ADDENDUM NUMBER 1

Project: Suite 320 Timeshare
19550 E 39th St. Suite 320
Independence, Missouri 64057

Date: June 23, 2016

3 FLOOR CLOSURE DETAIL

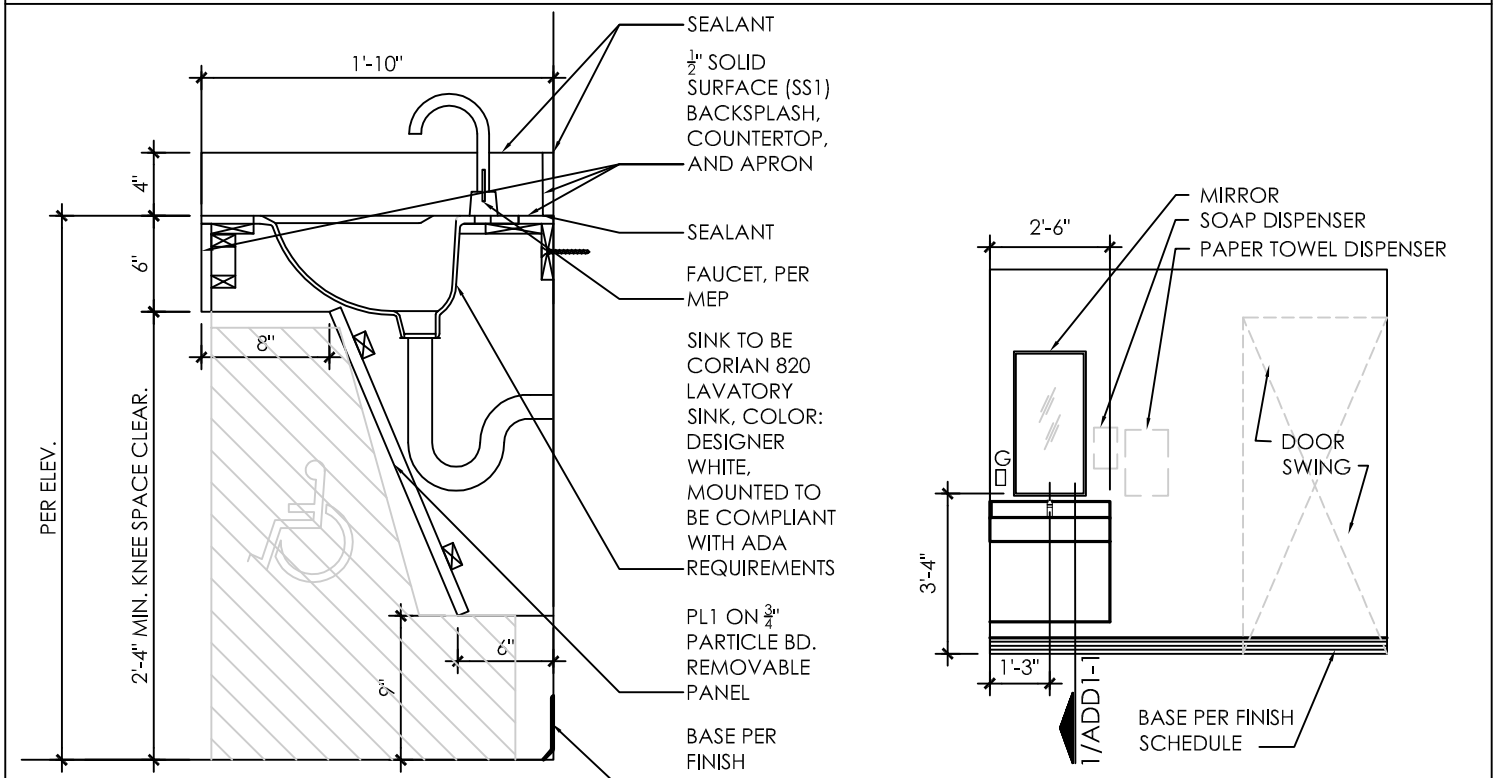
3. Please see 3/ADD1-1 attached for closure strip detail. This detail is to be maintained at all points along the exterior wall.
4. All work that requires access to public corridors or other suites shall be completed after the hours of 6:00 pm or before the hours of 7:00 am.

9 ELEVATION

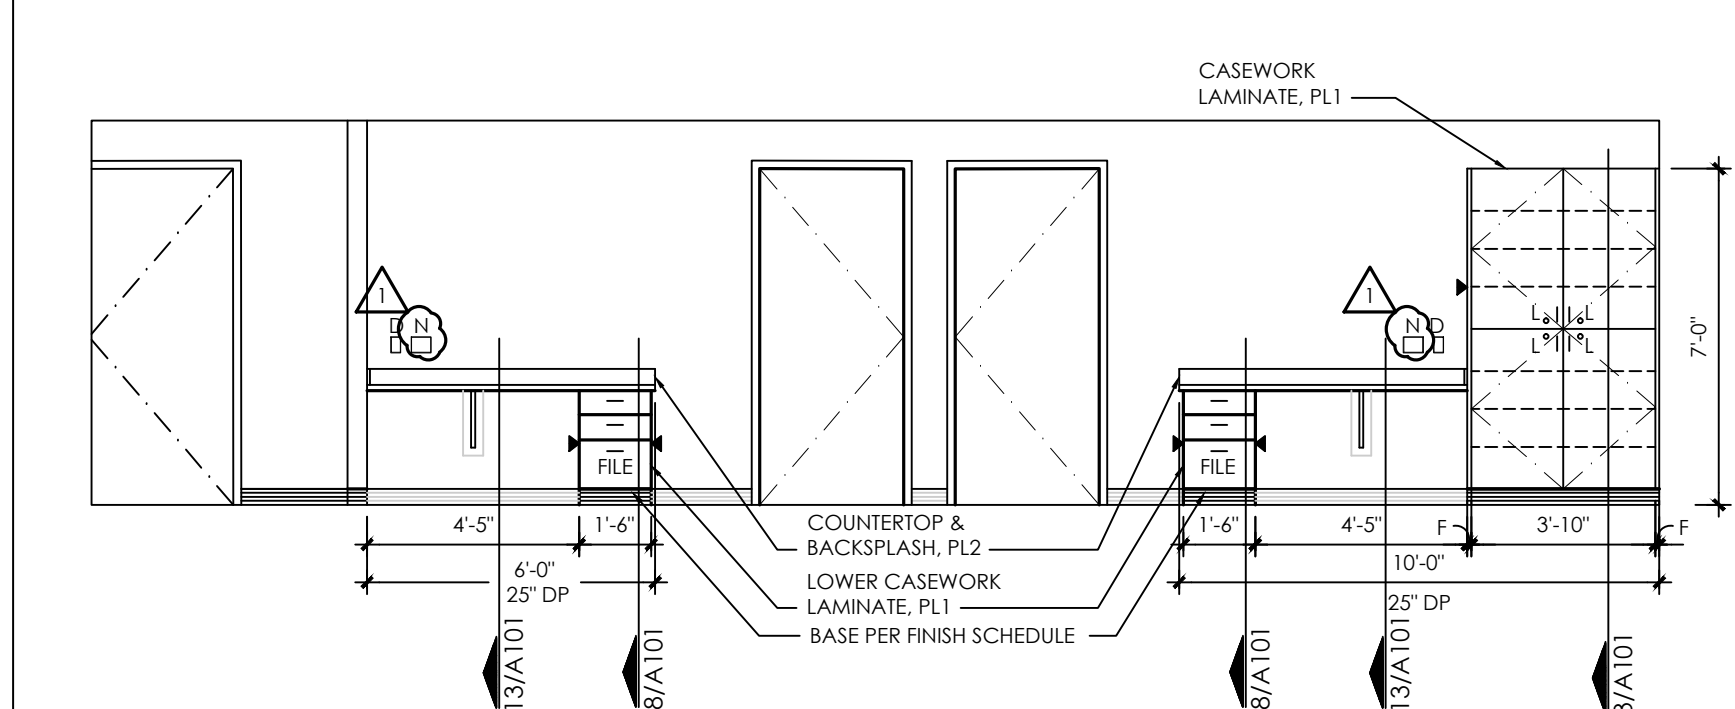
1. On all sheets, **CHANGE** project address to the following "19550 East 39th Street, Suite 320, Independence, Missouri 64057".
2. On drawing 1/COVER, 2/COVER, 9/COVER and 5/A101, **REVISE** outlets to coordinate with MEP drawings.

2 ELEVATION

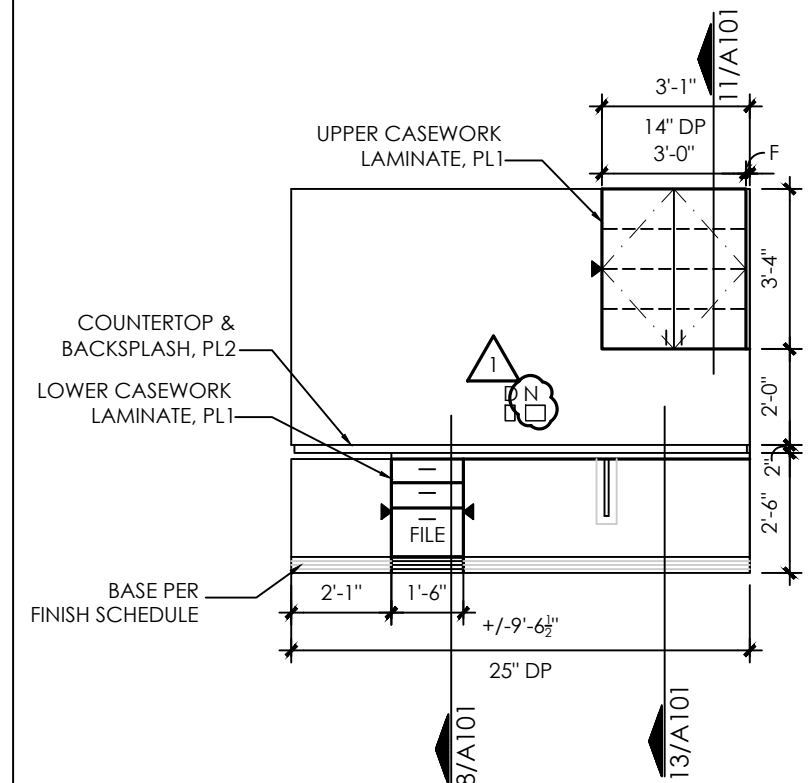
3. On drawing 2/COVER, **ADD** arrows showing the direction of sliding glass panels.
4. On drawing 4/COVER, **REVISE** outlet shown so that it is above ceiling per MEP.

5 ELEVATION

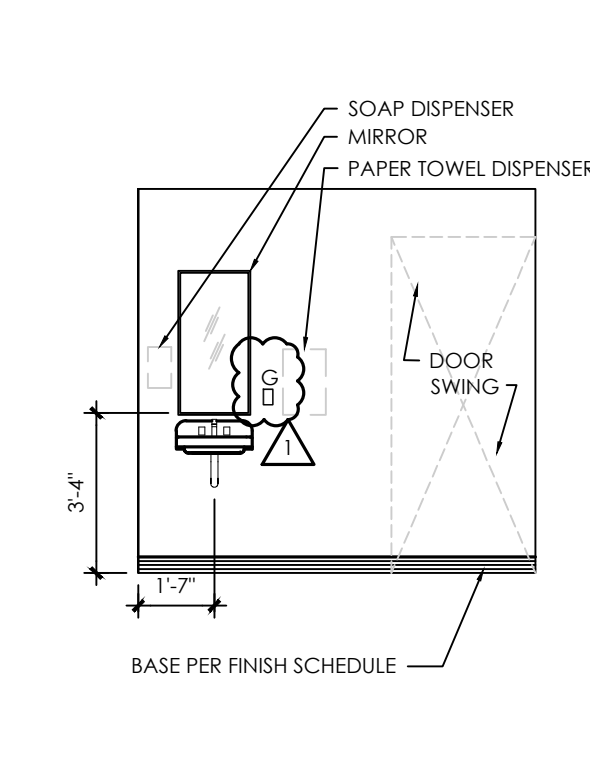
5. On drawing 5/COVER, **ADD** outlet per MEP.
6. On drawing 8/COVER, **REVISE** cabinet size and show electrical panel location.
7. On drawing 3/A101, **REVISE** detail.

15 DETAIL
SCALE: 3" = 1'-0"

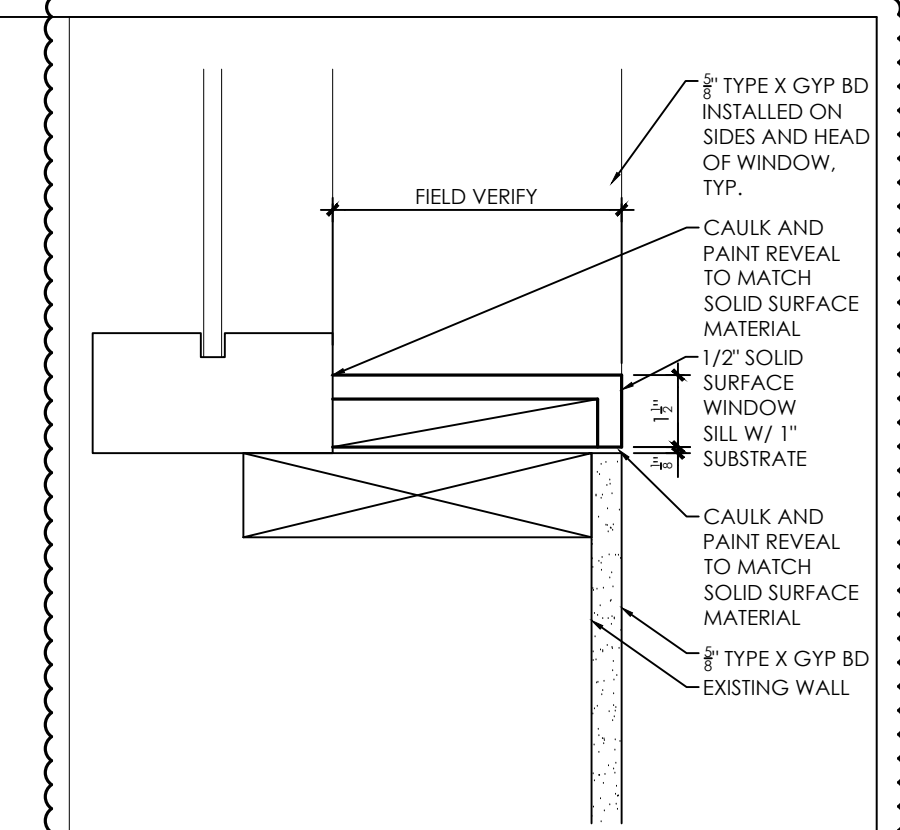
13. On drawing 15/A101, **REVISE** detail.
14. On sheet A/901, **REMOVE** "Division 15 – Mechanical" and "Division 16 – Electrical" in their entirety.
15. On sheet A/901, **REMOVE** "Division 8 – Doors and Windows, Section 8.4 Hardware Schedule" in its entirety and **REPLACE** the following language:

5 FLOOR PLAN SCALE: 1/4" = 1'-0"

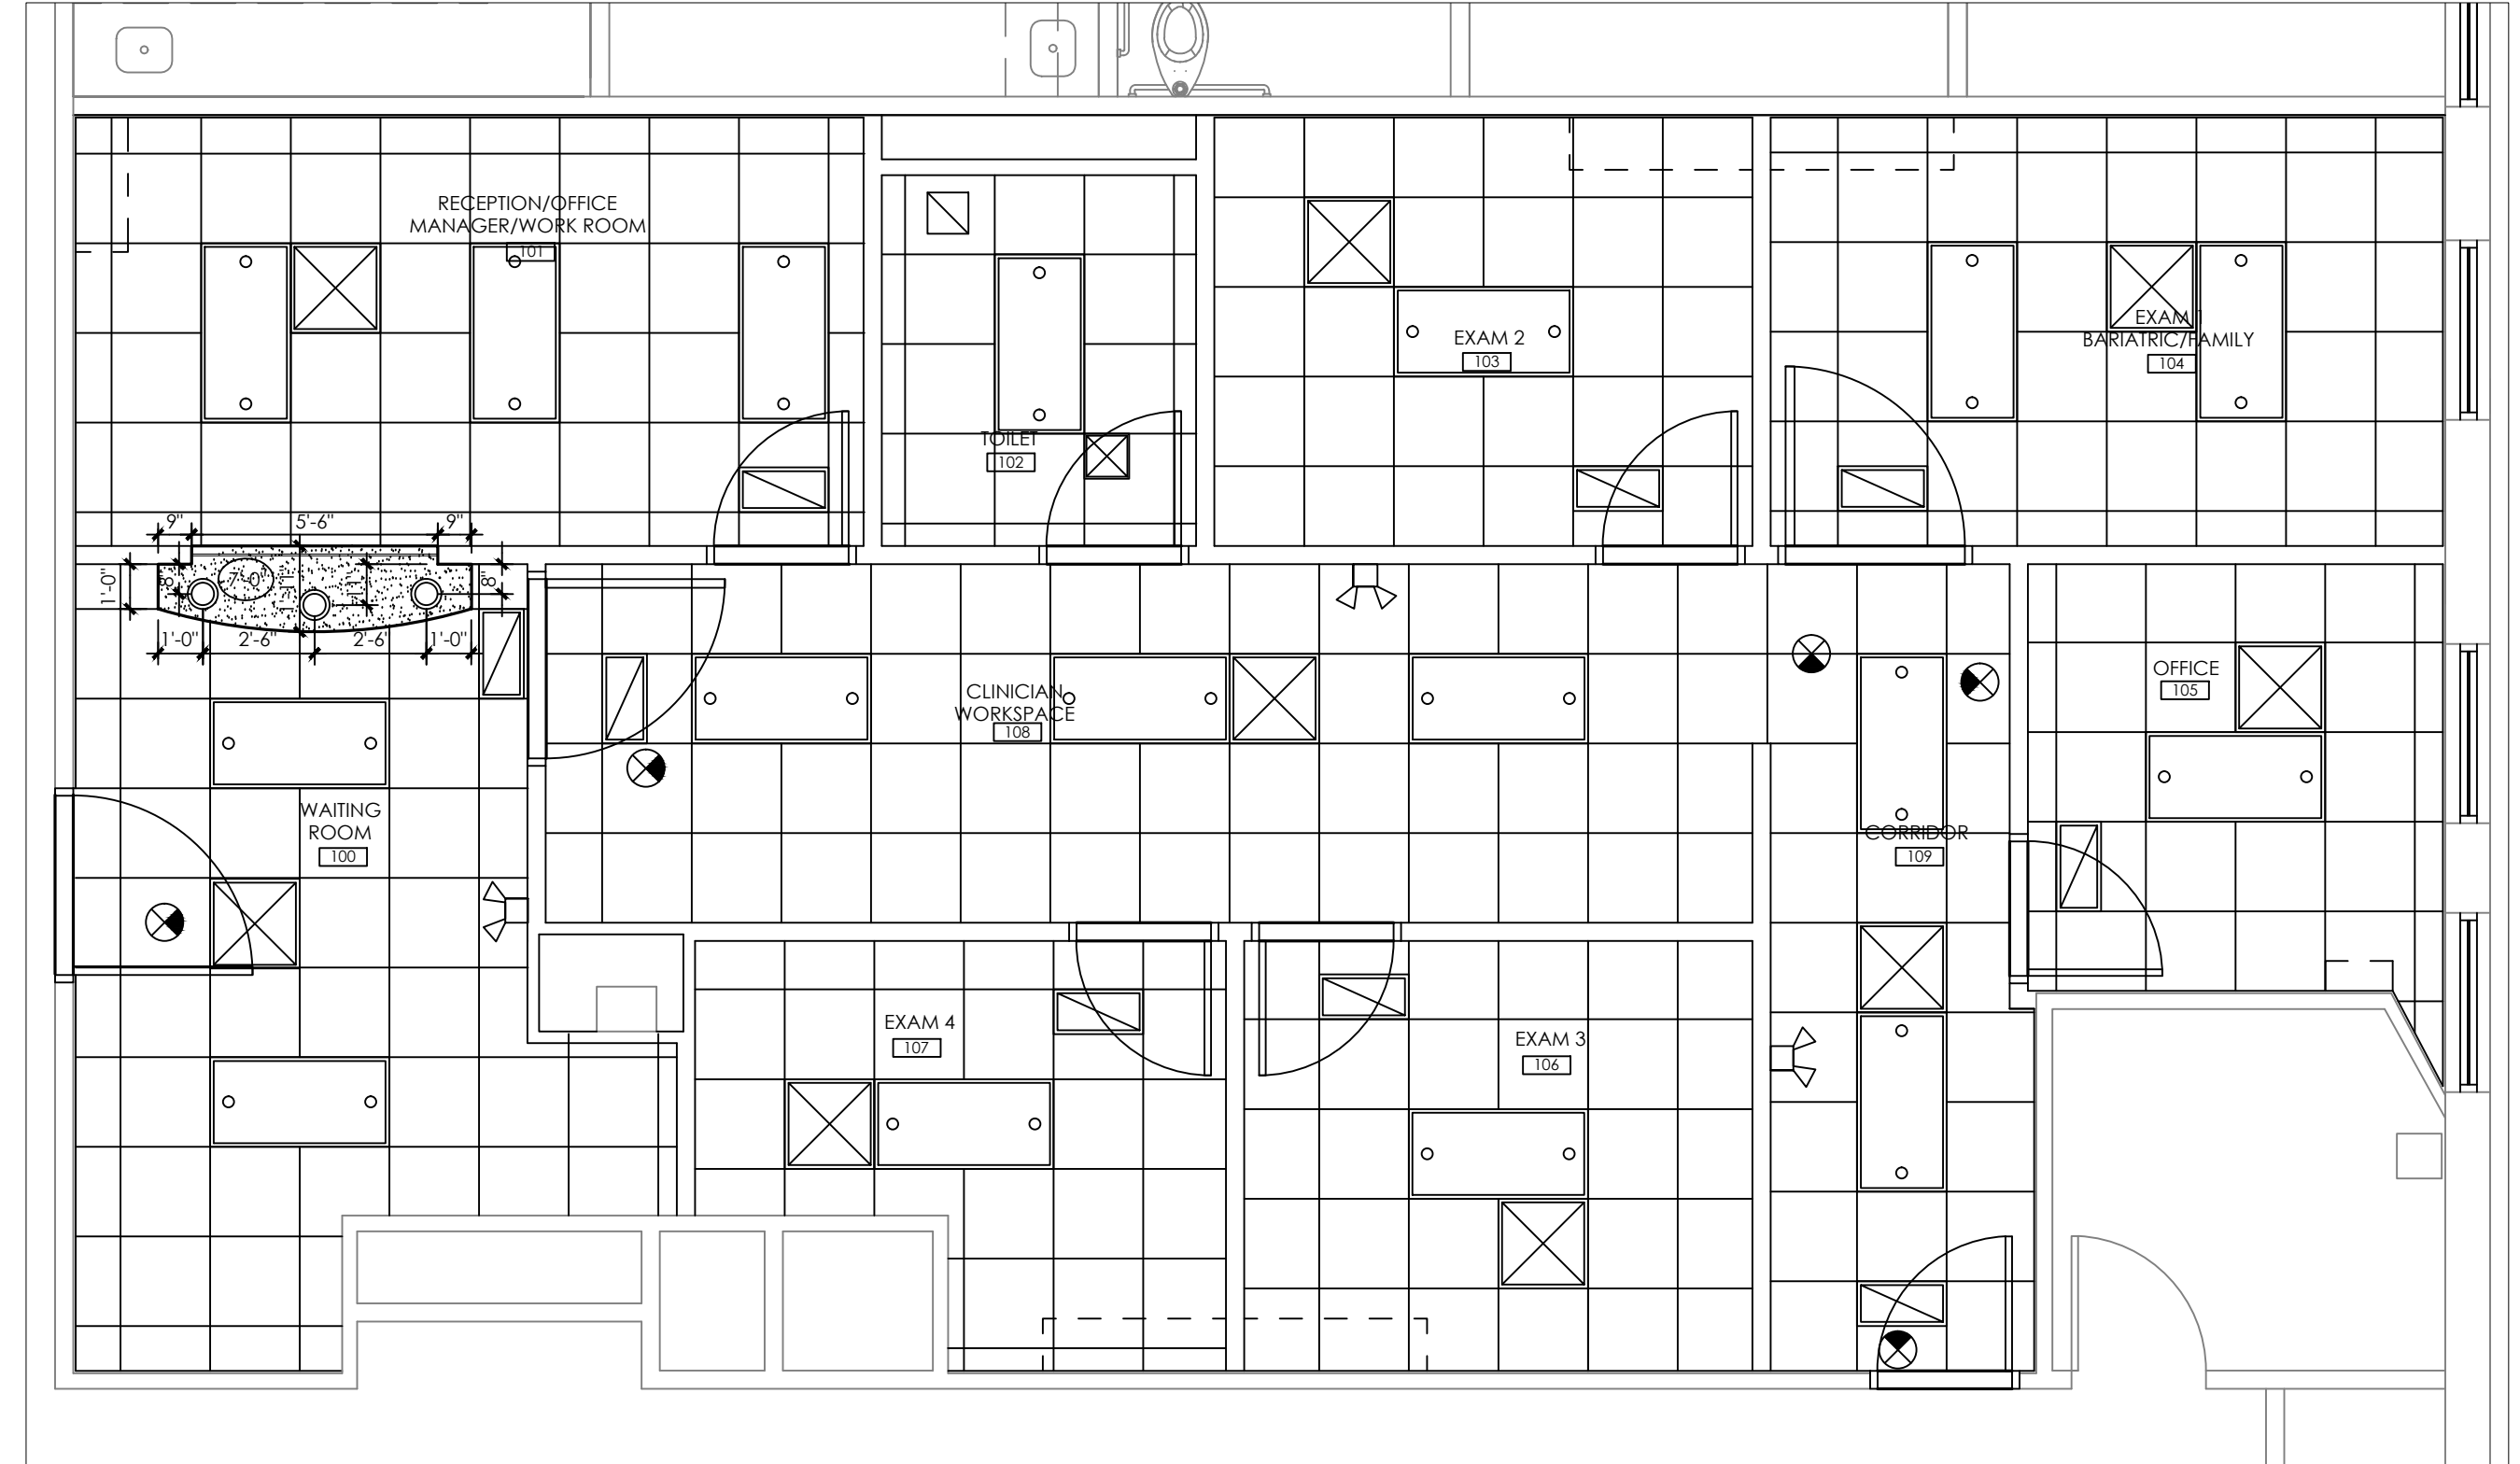
8. On drawing 5/A101, **ADD** the partition tag to the north wall of TOILET 102.
9. On drawing 5/A101, **REMOVE** dimension stringer in CORRIDOR 109.
10. On drawing 5/A101, **ADD** door operator symbols near door 100.

11. On drawing 5/A101, **ADD** keynote 23 to TOILET 102 for alt. bid #2. Please see 1/ADD1-1 and 2/ADD1-1 attached for details.
12. On drawing 5/A101, **ADD** batt insulation to all perimeter walls (excluding exterior walls) before installing gyp board per keynote 13.
